UNITED STATES PATENT AND TRADEMARK OFFICE

APPLICATION NO.	FILING DATE	FIRST NAMED INVENTOR	ATTORNEY DOCKET NO.	CONFIRMATION NO.
10/624,559	07/23/2003	Masaharu Nishikawa	50195-375	6633

Office Action Summary	Application No. 10/624,559	Applicant(s) NISHIKAWA, MASA HARU	
	Examiner Katherine W. Mitchell	Art Unit 3677

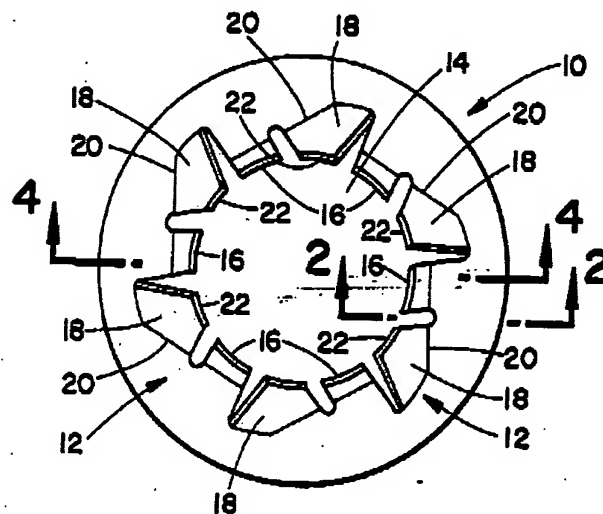
- A clip body 12 with an abutment part capable of attaching a first member to a second member, having a shank hole to accommodate passage of a bolt
- A plurality of engagement claws (spring fingers 18 and 16 are both considered claws, per Fig 4 and col 3 lines 51- col 4 line 41) formed around inner periphery of hole and radially projecting inward (Fig 1) and inclined to the clip body so that the respective tips depart in an axial direction from clip body, thereby providing claws as a whole a substantially cone-shaped configuration (Fig 3)
- Wherein engagement claws are capable of engaging bolt shank while urging first member toward second member along bolt axial direction (see Fig 4 below, and

- Wherein engagement claws include at least 2 specific claws adjoining in circumferential direction (Fig 1, adjacent claws 16 and 18, see Fig 1 below)

- Wherein the tips of two specific claws are apart from each other a predetermined distance in height (Fig 4, 18 higher than 16) and the height difference is equal to one or more thread pitches on the bolt shank.
- Examiner notes that Fisher teaches in col 1 lines 8-18 that the clips are commonly used to retain partial assemblies in an assembled relationship, thus inherently there are first and second members attached by the clip via a bolt.
